Summary	Replacing Car Wash Motors with new Ovitor Motor with curved black cover.				
Products Affected	Car Wash doors models WS3 & Clear Shield.				
Key Word Tags	Wyndstar, WS3, Clear Shield, Ovitor				
Tools/Equipment (If Required)	Sawz-all, Grinder, Wrenches				
Parts/Materials (If Required)	MTR,OVITOR STA1 208V 3600 RPM R920180 MTR,OVITOR STA1 460V 3600 RPM R920181				
Related Media					
Author	Randy Meyer, RevA M. Burzlaff	Issue Date	1/13/2011	Status	Active

Please Read The Entire Bulletin Before Proceeding

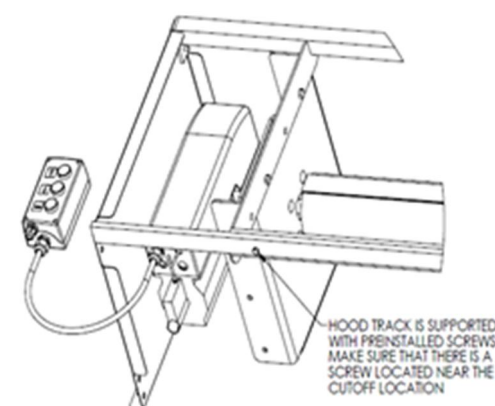
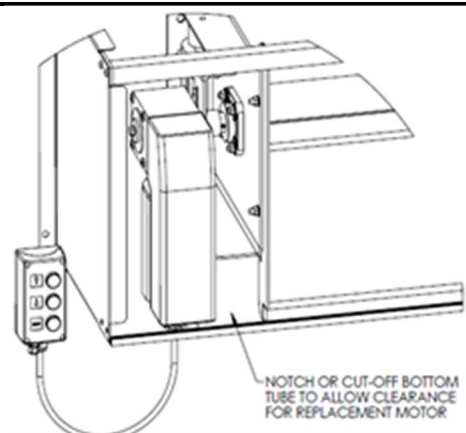
The motor manufacturer (Ovitor) has changed the design of the cover for the Ovitor motors from the original shipped with the door. The newly designed cover allows more space for routing the control wiring. This new design prevents interference with the internal up and down push buttons inside the cover that created problems in the previous design.

Since the cover has been redesigned and is larger, a modification must be completed to the door hood (cover). The piece of tube steel along the bottom of the front cover must be removed or notched out to accommodate the new Ovitor motor and cover. This can be performed using a sawz-all or grinder. The tube steel is bolted to the drum roll bracket therefore; the tube is supported and will not sag or swing free in the opening. The drawings below illustrate a left hand drive; right hand drive is the same condition. See the drawings below.
